On Amtrak's Mid-Atlantic Division, Main Line Philadelphia to Washington, Northeast Corridor, between Bridge interlocking located at MP 98.2, Baltimore, MD and Grove interlocking located at MP 112.4, Severn, MD, Amtrak plans to convert approximately 14 miles of its cab signal and fixed automatic block signal system to a signal system having cab signals without fixed automatic block signals, operated under NORAC Rule 562. As a result, Amtrak plans to retire the fixed wayside signals, as the automatic block signals are not necessary and require additional maintenance. Therefore, in accordance with Federal Railroad Administration's Rules, Standards and Instructions, 235.10 through 235.13, Amtrak hereby submits the following application seeking permission to remove these signals:

OFFICE OF THE DEPUTY CHIEF ENGINEER C&S		"GROVE" TO "BRIDGE" EXISTING AND PROPOSED LAYOUTS		Plan No.		
				Sheet No. 1 OF 3		
Phil., PA	Date: October 25, 2022	Approved: <i>[Signature]</i>	Designed BURNS	Drawn QM	Checked AWB	Date OCT 25, 2022

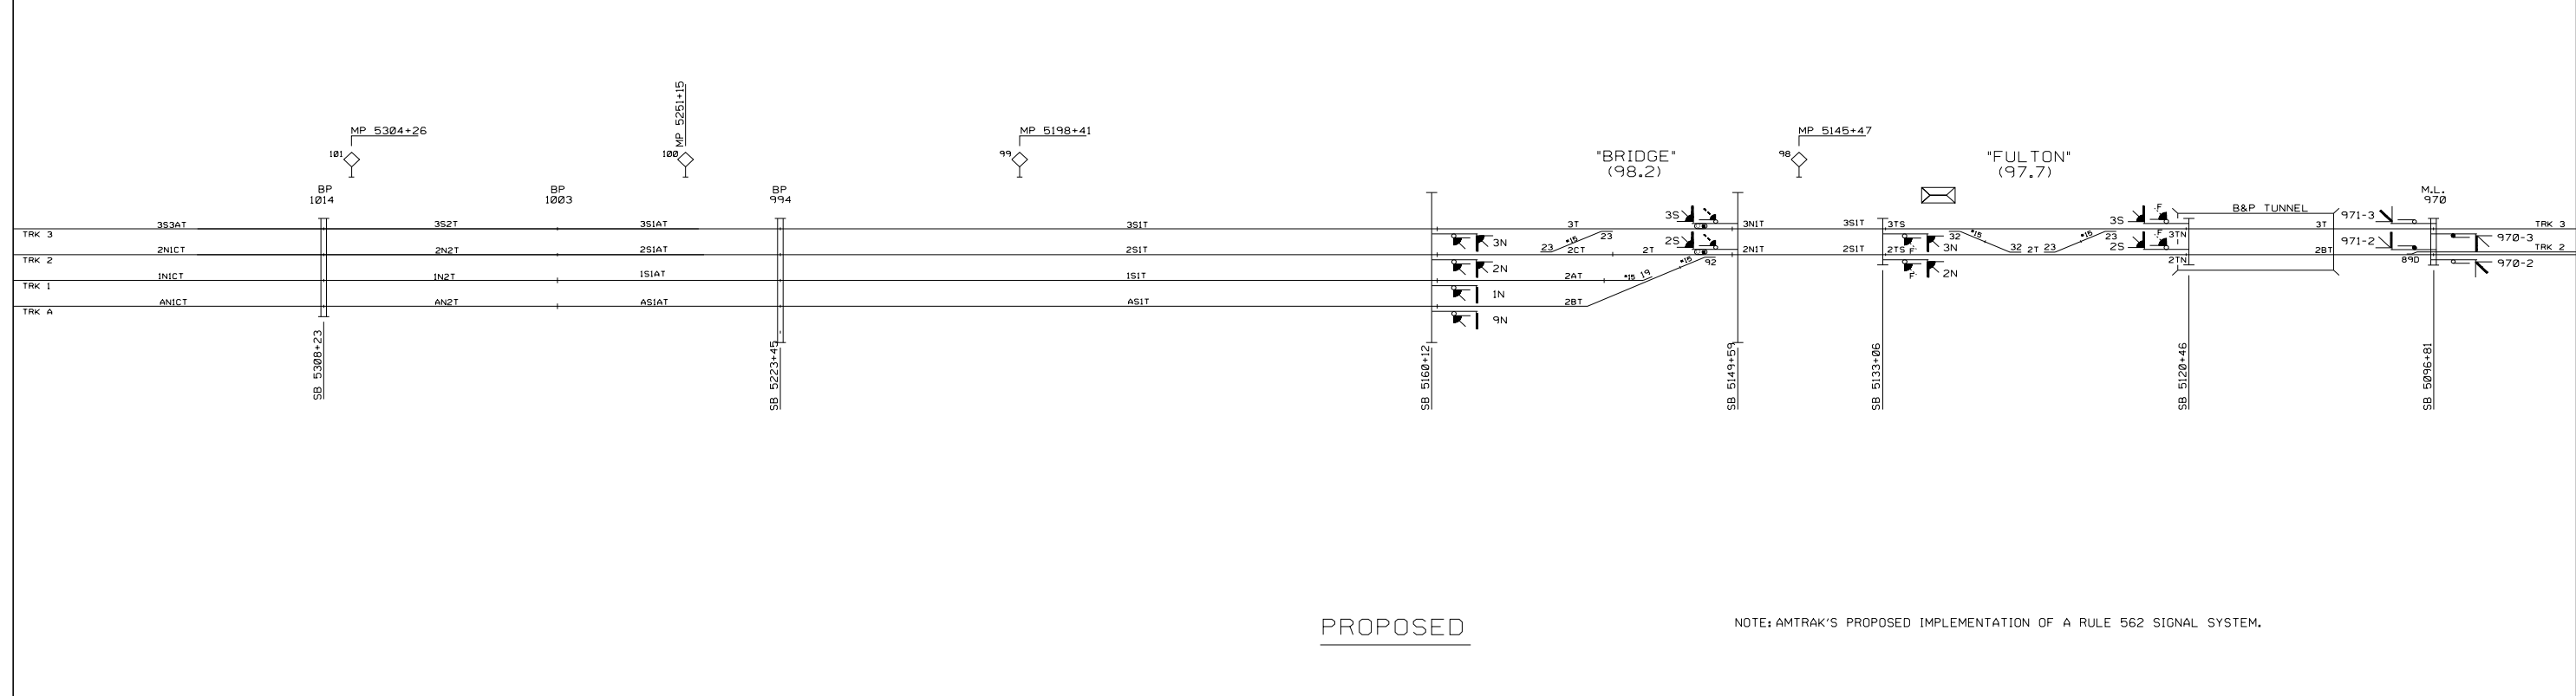
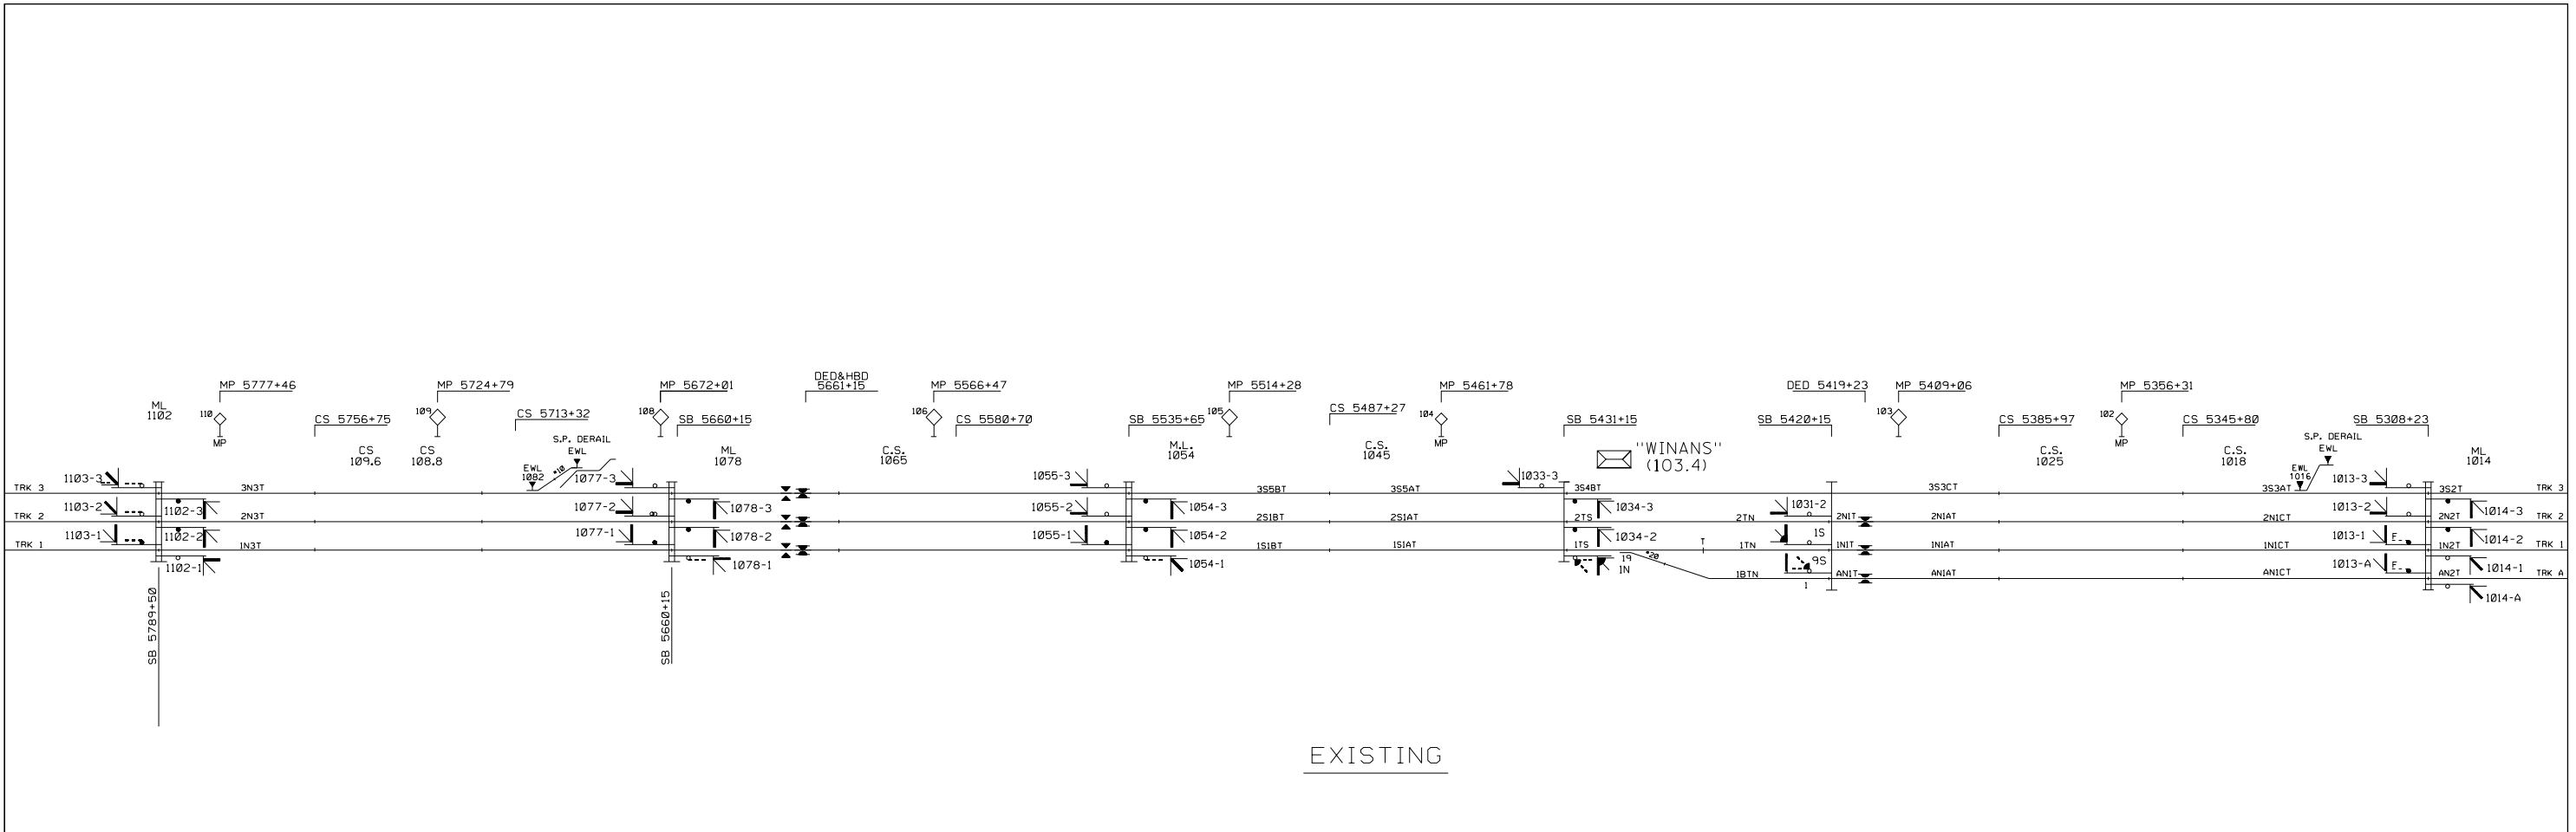
- (4) The tracks involved at each interlocking are Main Tracks No. 1, No. 2, No. 3 and A Track.
- (5) The changes proposed are to remove the wayside signals at automatic block points 994 and 1014 on Tracks No. 1, No. 2, No. 3 and A Track, wayside signals at automatic block points 1031 and 1034 on Tracks No. 2 and No. 3 and wayside signals at automatic block points 1054, 1078 and 1102 on Tracks No. 1, No. 2 and No. 3. All locations will remain in service as a block point without wayside signals.

- (6) The reason for removal of the signals is to eliminate maintenance and operation of unnecessary hardware no longer needed, and to reduce delays to trains caused by failures of the signals. The

NOTE: AMTRAK'S PROPOSED IMPLEMENTATION OF A RULE 562 SIGNAL SYSTEM.

"GROVE" TO "BRIDGE"
EXISTING AND PROPOSED LAYOUTS

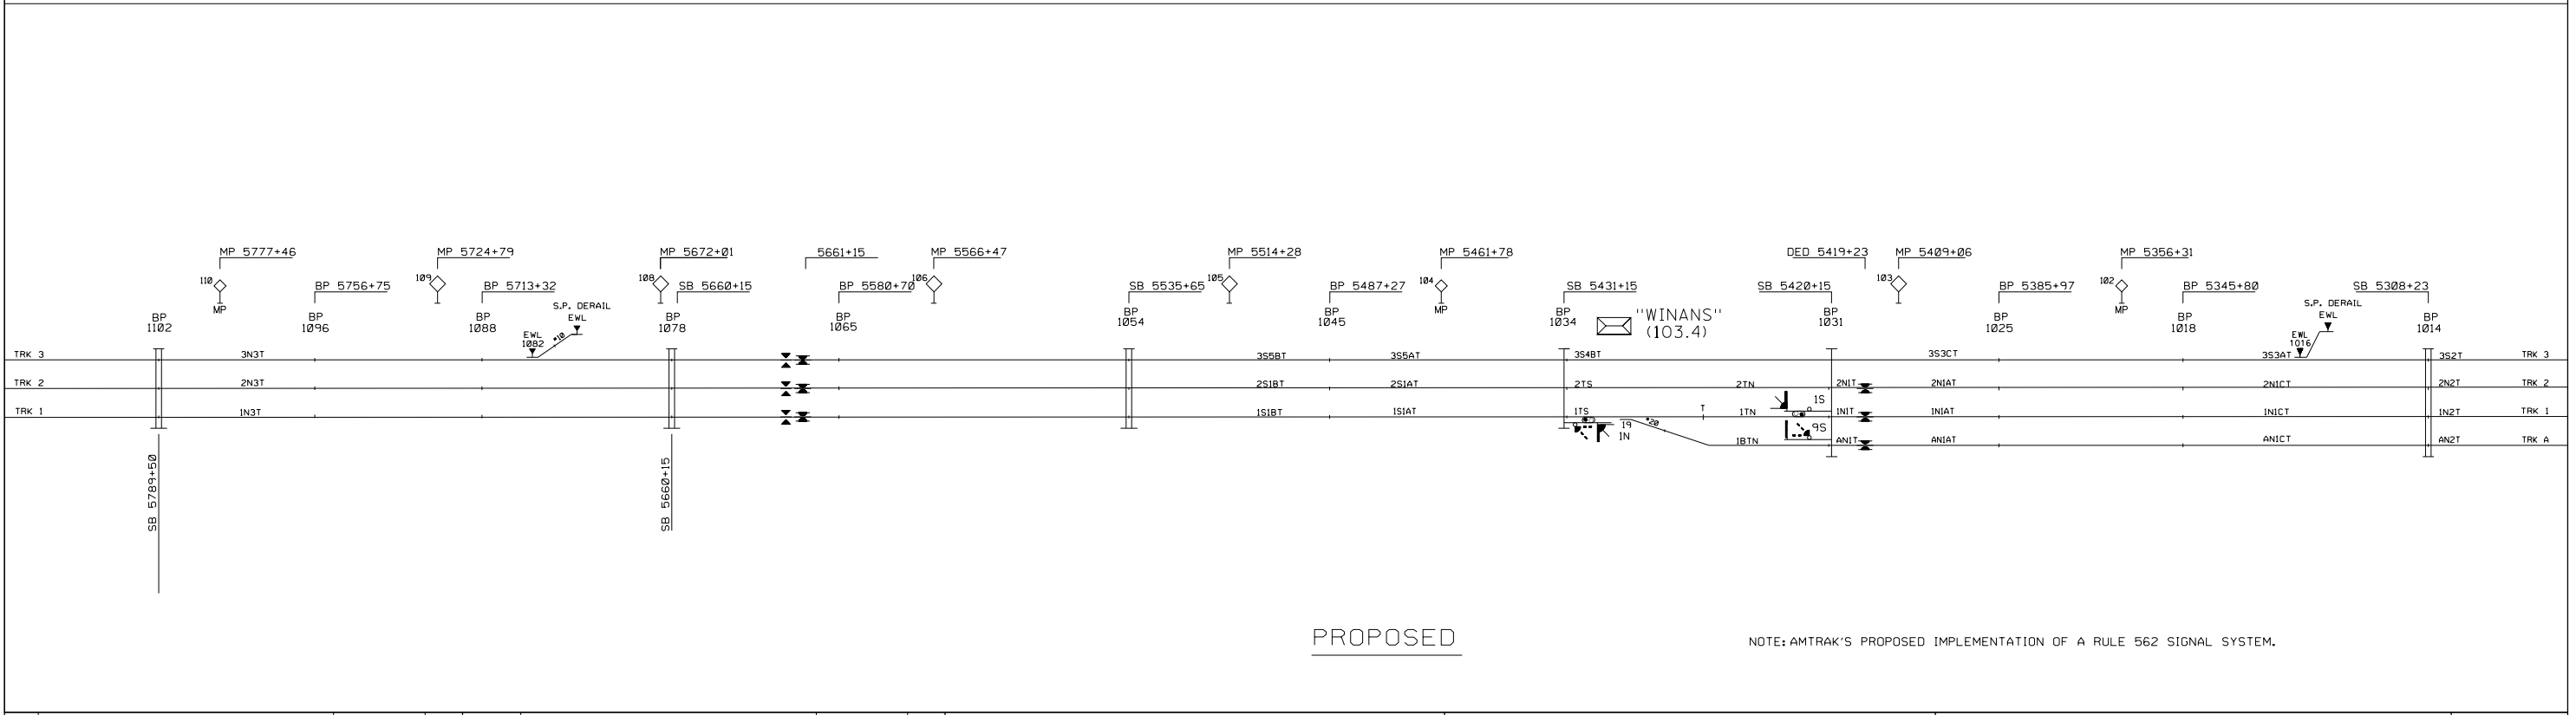
NOTE: AMTRAK'S PROPOSED IMPLEMENTATION OF A RULE 562 SIGNAL SYSTEM.

"GROVE" TO "BRIDGE"
EXISTING AND PROPOSED LAYOUTS

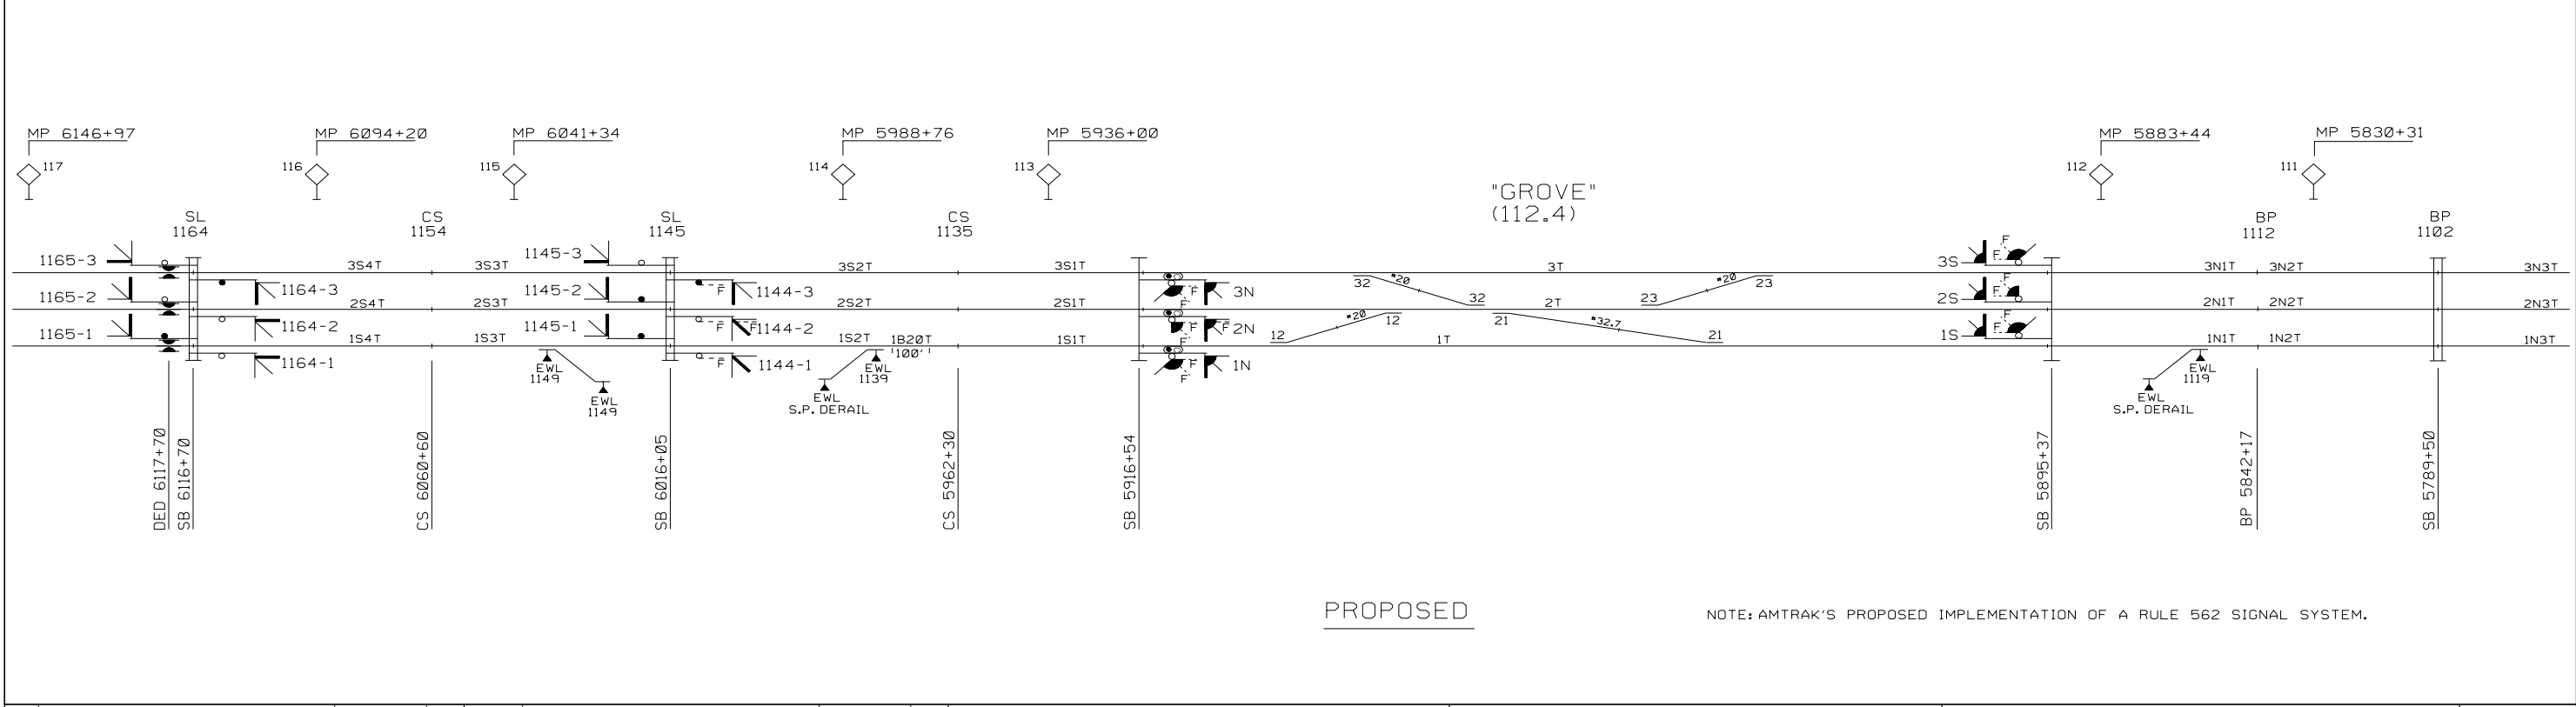
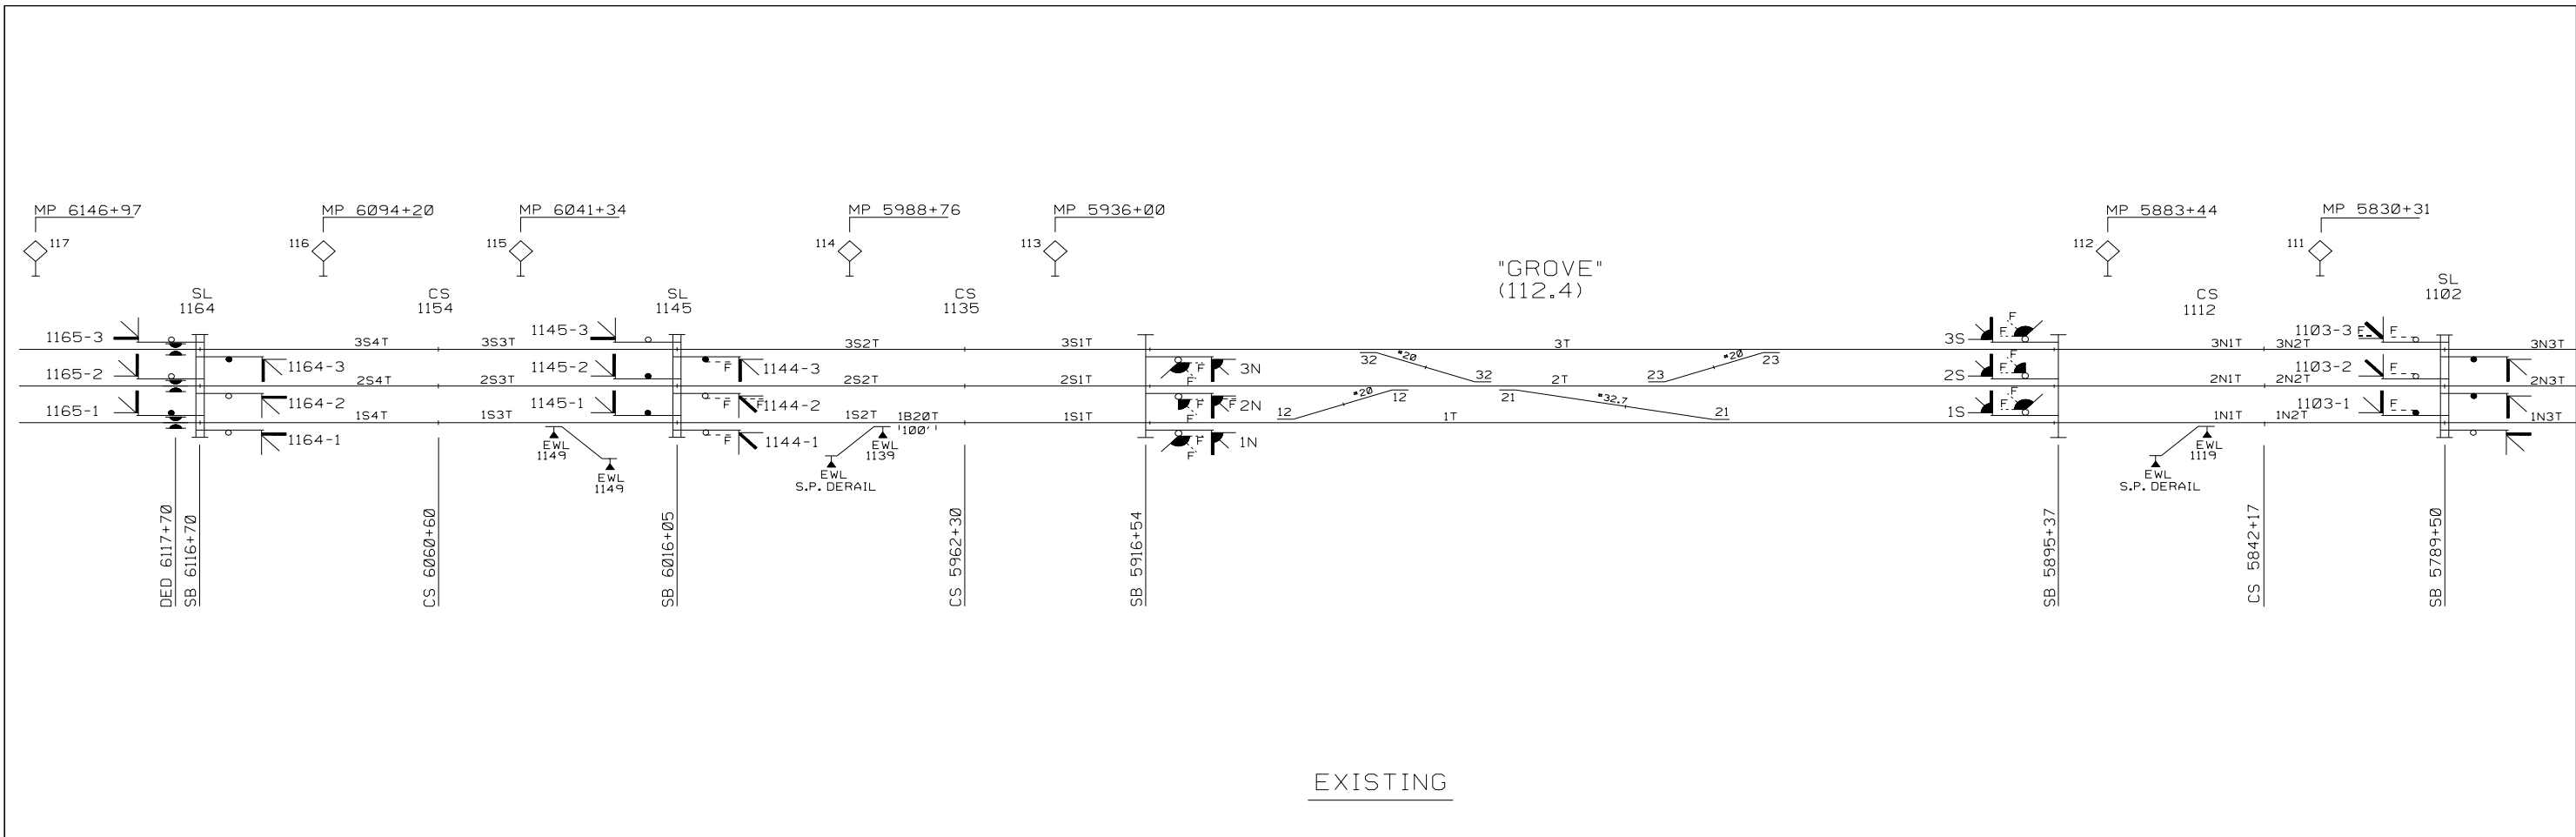
NOTE: AMTRAK'S PROPOSED IMPLEMENTATION OF A RULE 562 SIGNAL SYSTEM.
